## ZONING CHANGE REVIEW SHEET

**CASE:** C814-88-0001.10

Canyons at Rob Roy Rezoning

**ZONING TO:** PUD – Planned Unit Development, to change a condition of zoning

SHEET 1

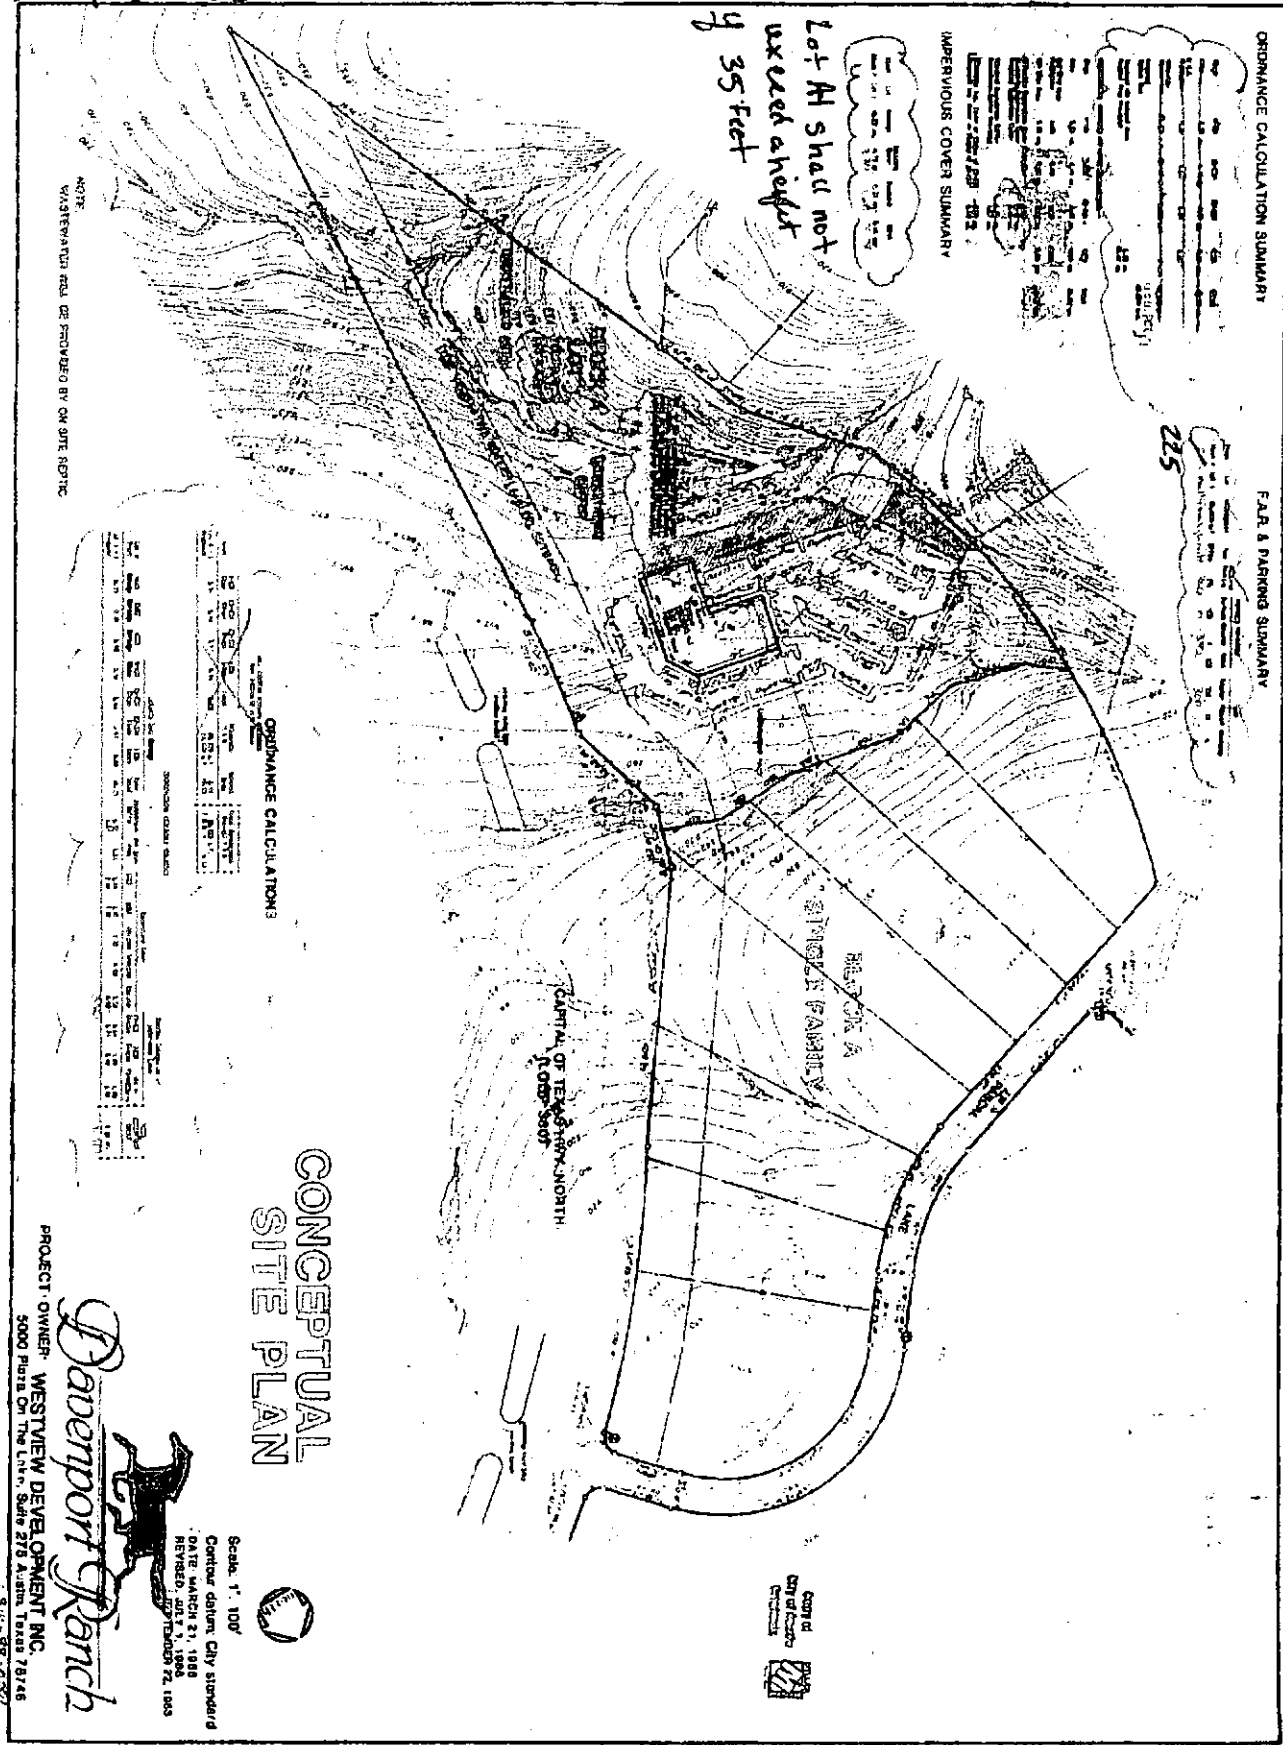
Exhibit "H" Land Use Plan. Change the Overall Summary by General Land Use Table on Sheet 1 to reflect a change from office use to multifamily use; adjust the acreages accordingly.

Exhibit "H" Land Use Plan. Change the Land Use Summary Table on Sheet 1 to reflect the correct lot and change the proposed land use from office to multifamily.

Justification. The Property was zoned for office use in 1988, since then it has remained undeveloped. West Austin lacks a sufficient supply of multifamily development for families looking to move to the area that otherwise might not be able to afford owning their own home. The few multifamily developments located in the surrounding area experience an occupancy rate of over 90%. Additionally, the proposed low density multifamily residential use provides a better transition between Capital Texas Highway located to the west and the residential uses located to the north and east of the site.

Justification. The Property was zoned for office use in 1988, since then it has remained undeveloped. West Austin lacks a sufficient supply of multifamily development for families looking to move to the area that otherwise might not be able to afford owning their own home. The few multifamily developments located in the surrounding area experience an occupancy rate of over 90%. Additionally, the proposed low density multifamily residential use provides a better transition between Capital Texas Highway located to the west and the residential uses located to the north and east of the site.

SHEET 2

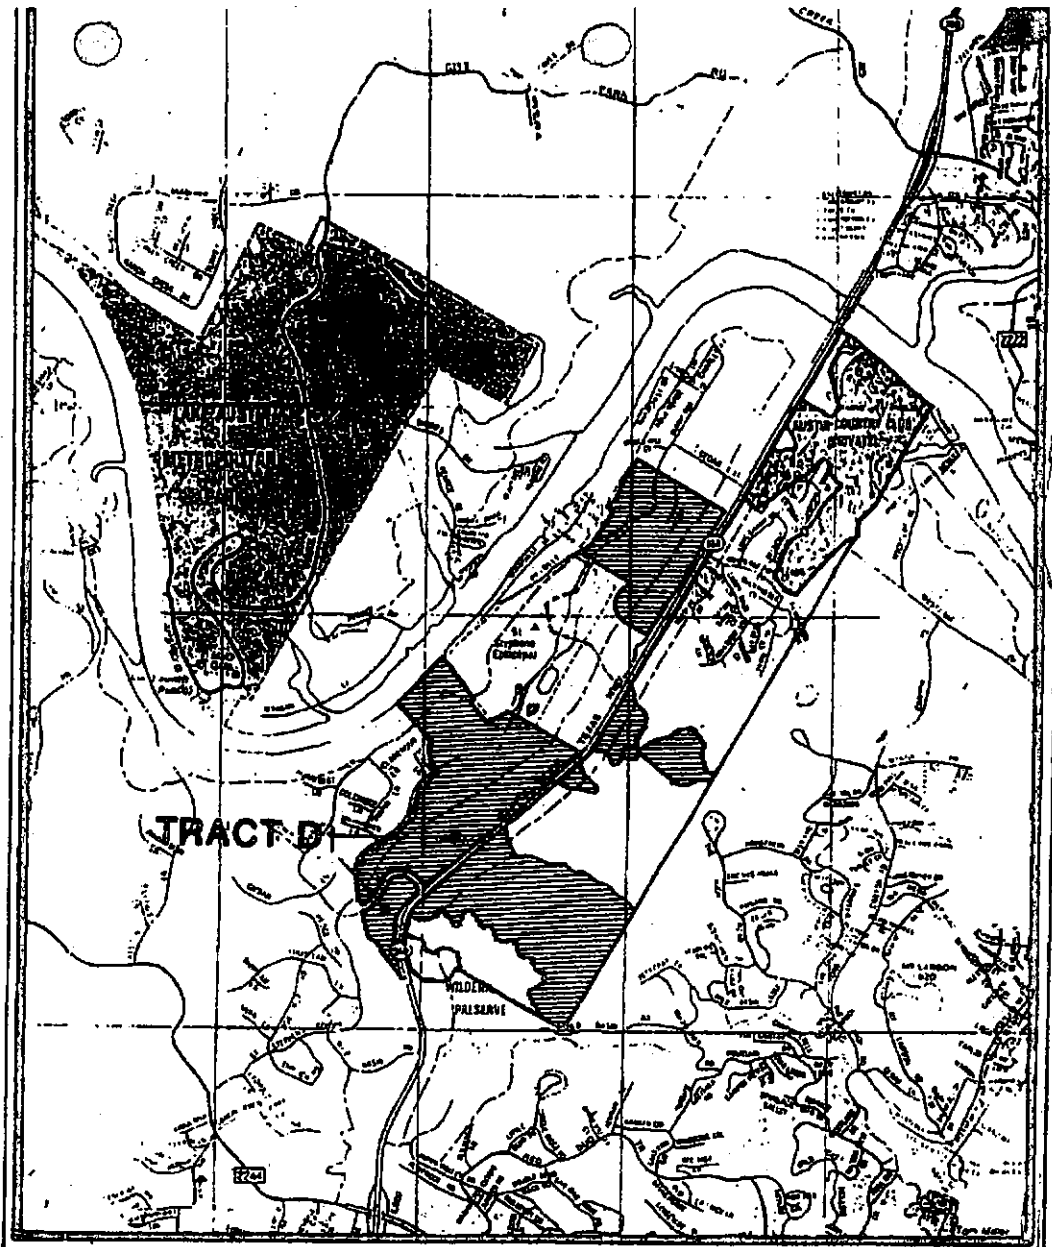
Exhibit "H" Land Use Plan. Clarify Ordinance Compliance Note #1 on Sheet 2 to read "*Single family*" residential areas are limited to a density of one unit per two acres of gross site area, with minimum one acre lots."

Exhibit "H" Land Use Plan. Change the Hill County Roadway Ordinance Calculations on Sheet 2 to deduct the site area calculations of Lot A-1.

Exhibit "H" Land Use Plan. Change the F.A.R & Parking Summary Table on Sheet 2 to reflect Lot A-1 as a multifamily project.

Exhibit "H" Land Use Plan. Change the diagram on Sheet 2 for Lot A-1 from "LO" to "MF-2".

Justification. As supported by Section 1.04 of the Restrictive Covenant recorded in Volume 10909, Page 1601 of the Real Property Records of Travis County, Texas for the Davenport Ranch West Planned Unit Development Section One, this restriction was intended to apply solely to single family residential development. I have attached a copy of the Restrictive Covenant for your reference with the companion Restrictive Covenant Amendment case.

Justification. Per the Hill County Roadway Ordinance the floor to area limitations only apply to nonresidential (defined as single family residences, two-family residence or duplex) buildings.

Justification. The parking table only provides parking calculations associated with the office development on Tract D. Since the use is changing from office to multifamily we have updated the table accordingly.

Justification. The Property was zoned for office use in 1988, since then it has remained undeveloped. West Austin lacks a sufficient supply of multifamily development for families looking to move to the area that otherwise might not be able to afford owning their own home. The few multifamily developments located in the surrounding area experience an occupancy rate of over 90%. Additionally, the proposed low density multifamily residential use provides a better transition between Capital Texas Highway located to the west and the residential uses located to the north and east of the site.

006 SHEET 3

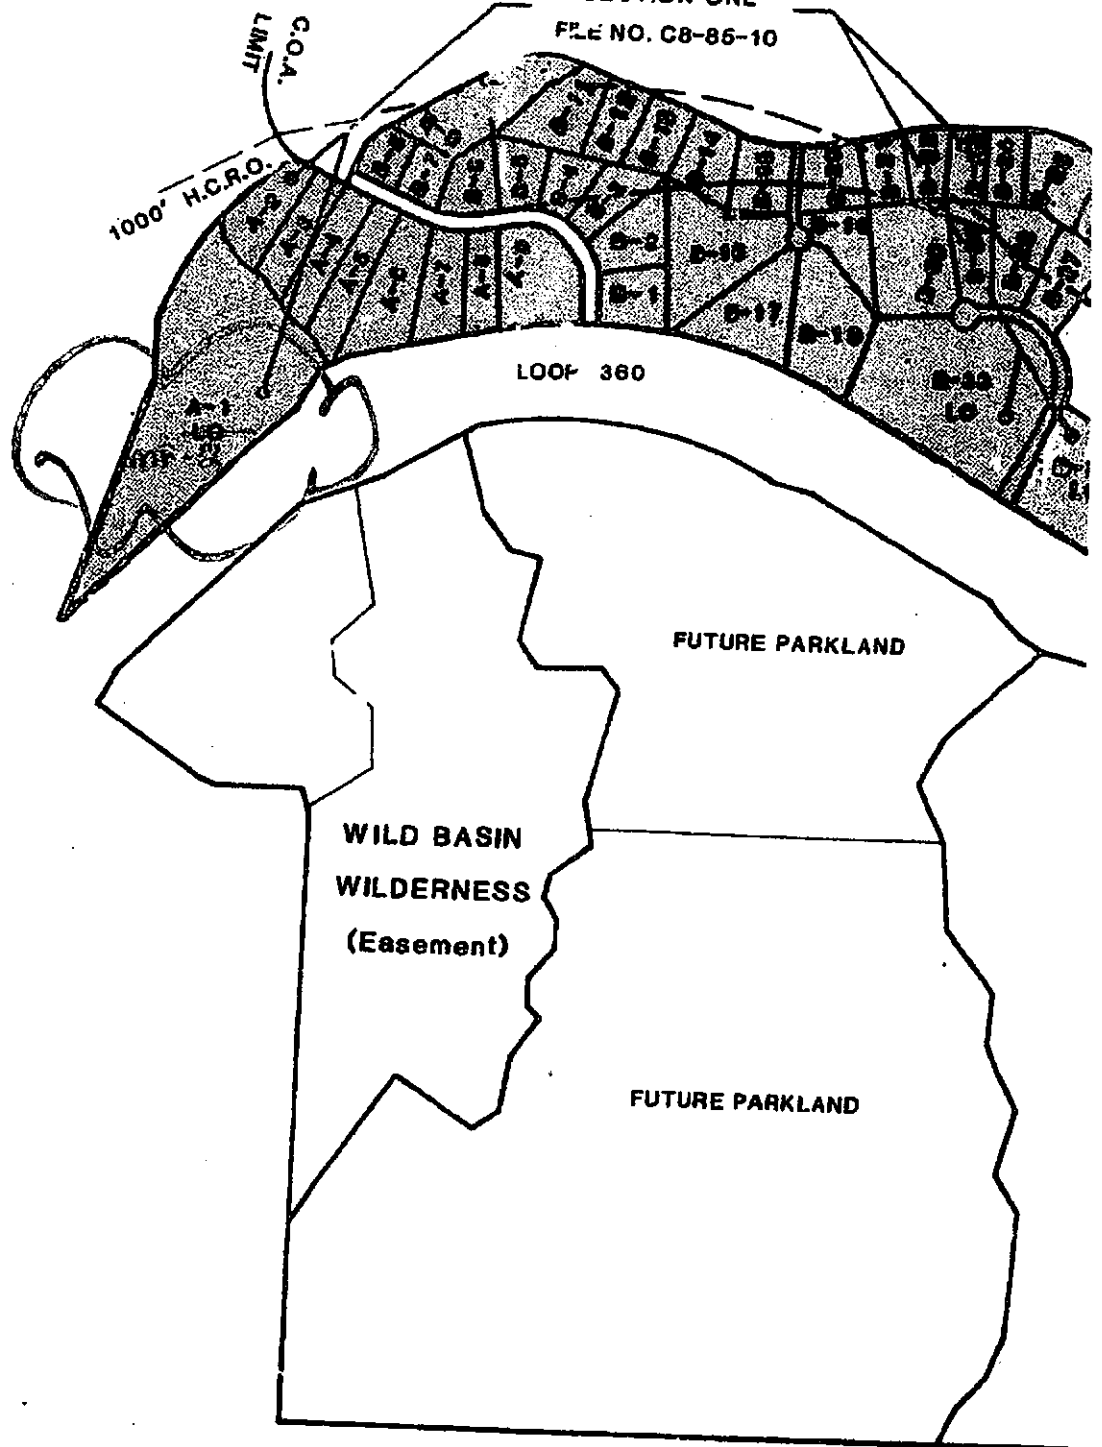
Exhibit "H" Land Use Plan. Remove the floor to area multiplier calculations and the allowable square footage calculations on Sheet 3.

Exhibit "H" Land Use Plan. Change the proposed impervious cover from 3.16 acres to 3.50 acres.

Exhibit "H" Land Use Plan. Change the Impervious Cover Summary Table on Sheet 3 to reflect the proposed impervious cover and to account for a different building configuration and parking layout.

Exhibit "H". Land Use Plan. Remove the Hill County Roadway Ordinance Table on Sheet 3.

Exhibit "H" Land Use Plan. Change the Comprehensive Watershed Ordinance Table on Sheet 3 to reflect the proposed impervious cover.

Exhibit "H" Land Use Plan. Remove the diagram on Sheet 3 of the office project.

Exhibit "H" Land Use Plan. Add a note on Sheet 3 that clarifies the maximum height allowed on Lot A-1 is 35 feet.

Exhibit "H" Land Use Plan. Remove the note on Sheet 3 that reads "Due to the pitch of the roof design and height limitations the square footage of the third story of this building will be reduced by approximately 50% from the first two stories.

Justification. Per the Hill County Roadway Ordinance the floor to area limitations only apply to nonresidential (defined as single family residences, two-family residence or duplex) buildings.

Justification. While the proposed impervious cover is slightly more than the previous office project, this project is still under the 3.52 acres of impervious cover allowed for Lot A-1.

Justification. While the proposed impervious cover is slightly more than the previous office project, this project is still under the 3.52 acres of impervious cover allowed for Lot A-1. The prior office project proposed a vast amount of surface parking with a small building footprint. Since the use of the site is changing from office to multifamily the size and configuration of the building and parking area must also change to accommodate a more user friendly development. The proposal is to provide a wrapped product type with structured parking within.

Justification. Per the Hill County Roadway Ordinance the floor to area limitations only apply to nonresidential (defined as single family residences, two-family residence or duplex) buildings.

Justification. While the proposed impervious cover is slightly more than the previous office project, this project is still under the 3.52 acres of impervious cover allowed for Lot A-1.

Justification. Zoning is used to establish the best use for a site and should not be used to dictate the location of site improvements. This should be deferred to the site development stage when engineered documents and related reports are available to assess the proper location of improvements based on site constraints. Also by removing the diagram from the land use plan it

Justification. There is no change from the previous proposal.

Justification. This note is unnecessary since the building is limited to 35 feet with height limit exceptions, as prescribed by 25-2-531 of the City Code, for certain architectural elements including pitched roof designs.
